Our Ref: 030/2024/01-CAG - Please quote in all correspondence.

**Re: DC/22/1887/FUL | - Create access into All Saints Golf and Country Club | Land Off The Street
Fornham All Saints Suffolk- Transport Statement**

7400.AR01. rev D Reinstate Historic Access For Maintenance -General Arrangement

Figure 1: Source: Crashmap UK. No records personal injury accidents, past 24 years

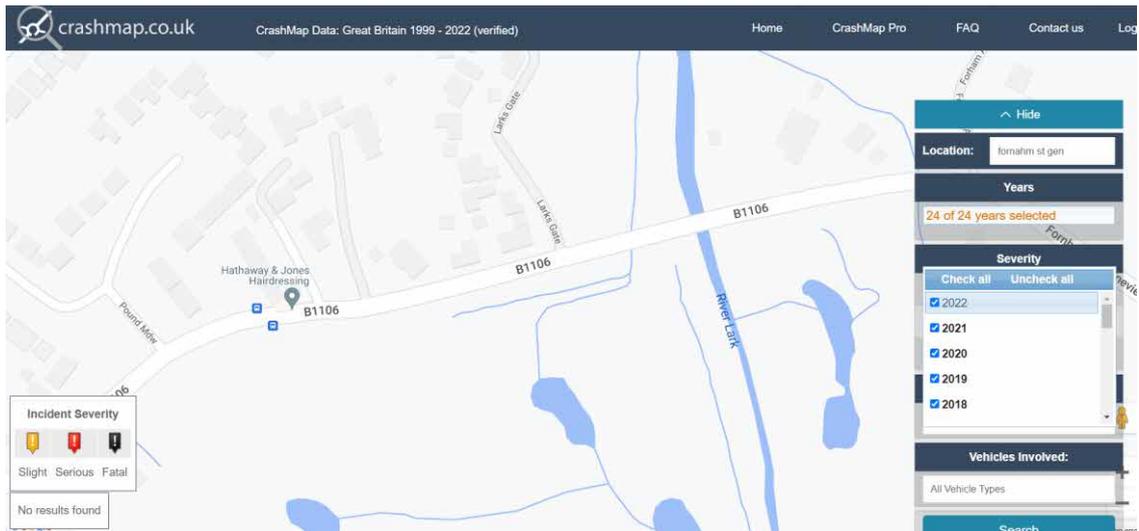
2. Additional traffic / road safety hazard as vehicles turn onto / off the B1106, in an area of already heightened risk, owing to the bend to the west, humped-bridge to the east, existing domestic access routes to the north and prevalence of speeding vehicles.

Response: Crashmap UK: Extract Figure 1: No evidence of reported road injury accidents in past 24 years. No evidence there is an underlying road safety issue on this road.
